Subject: Dresden Nuclear Power Station Units 2 and 3
Quad Cities Nuclear Power Station Units 1 and 2
Request for EXIGENT LICENSE AMENDMENT,
to Facility Operating Licenses DPR-19, DPR-25, DPR-29, and DPR-30
NRC Docket Nos. 50-237/249 and 50-254/265

DESCRIPTION AND SAFETY ANALYSIS OF THE PROPOSED CHANGES

BACKFILL MODIFICATION DRESDEN/QUAD CITIES

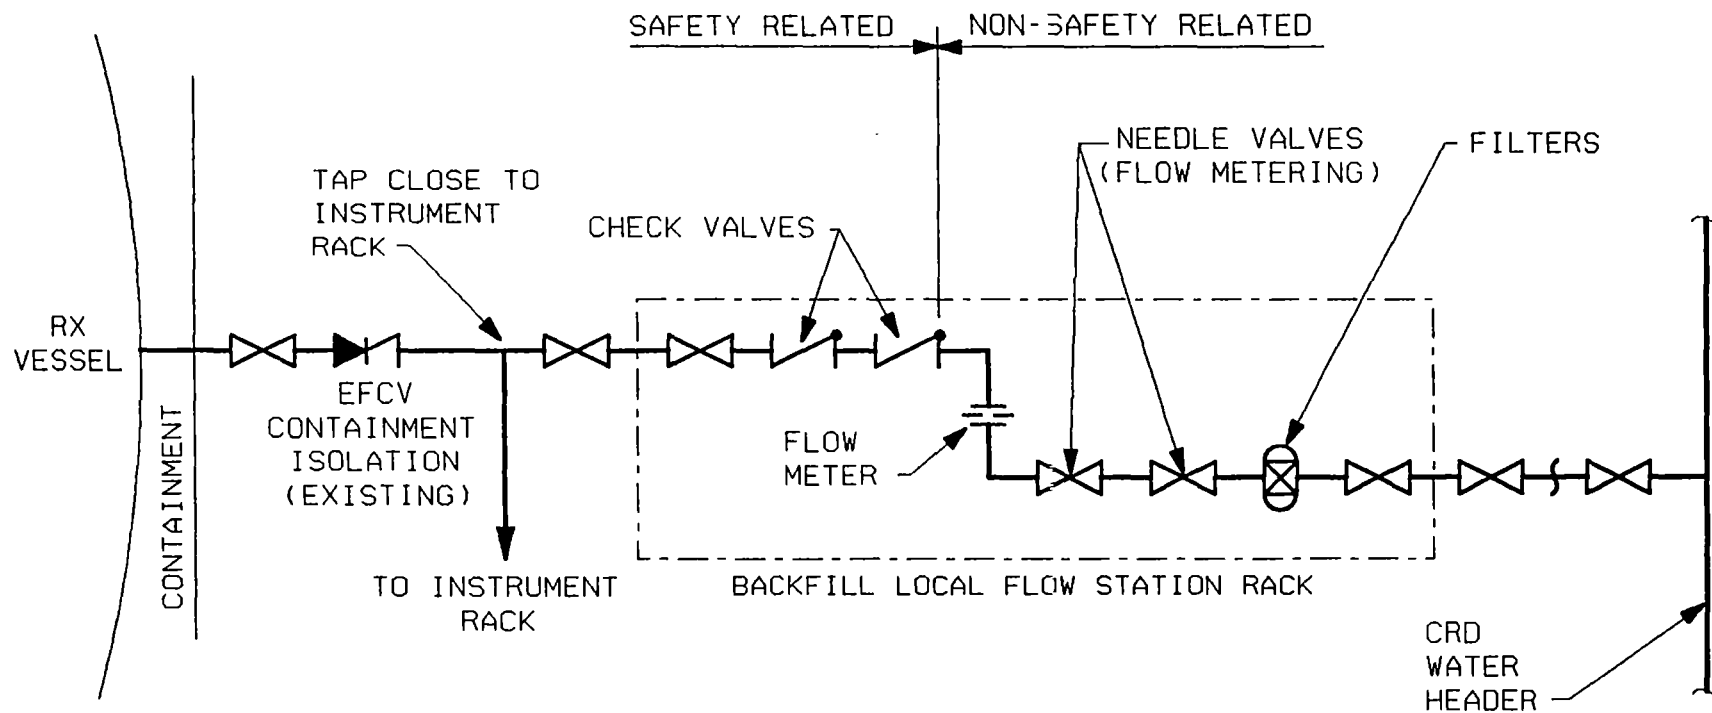
Implementation of the modification creates the potential for pressurizing one of the RVLIS reference legs to CRD drive water header pressure in the event of a root valve closure with the backfill subsystem in operation (see attached drawing). The condition could activate RPV low level safety features as well as RPV high pressure safety features depending on which valve is closed.

The new backfill subsystem utilizes water from the CRD drivewater header. This water supply flows to each of 2 instrument racks, 2201(2)-5 and 2201(2)-6 at Quad Cities and 2202(3)-5 and 2202(3)-6 at Dresden. Near these racks is a new panel with 2 flow stations and a water filter which acts as a pressure snubber. Each flow station consists of: needle valves for system startup and shutdown; metering valves for flow regulation; local flow indicators for setting flow rates through the backfill line for each reference leg; multiple check valves for SR-to-NSR and/or system separation; instrument taps for testing components; a vent connection for purging air from the lines; and isolation valves to isolate components for maintenance. A detailed drawing of the preliminary design is attached.

The increased significance of the inadvertent valve closure described above causes these events to be similar to previously analyzed accidents and transients. For example, the event on the reference leg from the 12A condensate pot causes the Target Rock and Electromatic Relief Valves to immediately open causing a loss of coolant. Other ECCS systems and RCIC (for Quad Cities) start and inject into the vessel in a manner similar to a Loss of Coolant Accident (LOCA). If the reference leg from the 13A or 13B condensate pot is isolated and that loop is being used for feedwater level control, the response of the plant is similar to a failure open of a feedwater regulating valve. The feedwater pump runout trip would not occur, but the high water level trip of the feedwater pumps and turbine would still be operable. The potential valve manipulation errors, therefore, can be considered an "increase in the probability of occurrence or consequences of an accident or malfunction of equipment important to safety." The installation of the modification with this configuration represents an Unreviewed Safety Question under paragraph "a(2)i" of 10CFR50.59. NRC review and concurrence with the No Significant Hazards Analysis is required.

The failure of the CRD piping integrity could result in challenges to the RPV instrumentation due to reference leg leakage. The isolation action of the two (2) backfill instrument line check valves mitigates this condition. The check valves allow flow to the vessel instrumentation reference leg piping and prevent flow out of the reference leg piping.

The primary concern is a mismanipulation of the valves while the unit is at power. This scenario is unlikely because these valves are located at the penetration where there are no normally operated valves. To further minimize the possibility of a valve error, the valves will be locked in the open position with a lock, the keys for which are administratively controlled. In addition, labels that clearly identify the valves will be provided at the valve location indicating that operation of the valves will result in a plant transient and that they are not to be operated without permission of shift supervision.

instrumentation integrity is adequately maintained in the event of CRD system depressurization. The basis for the check valve leakage shall be calculated to verify that the leakage from the reference leg piping over an acceptable time period is limited to an appropriate value. A loss of inventory greater than this value to the reference leg would excessively degrade indicated vessel level. Small deviations are acceptable for ensuring level instrumentation actuations are within analytical limits and ensures that vessel level indication is adequately provided to the Operator for assessing plant conditions. A time period will be established to ensure that recognition of the condition is made and isolation of the piping occurs.
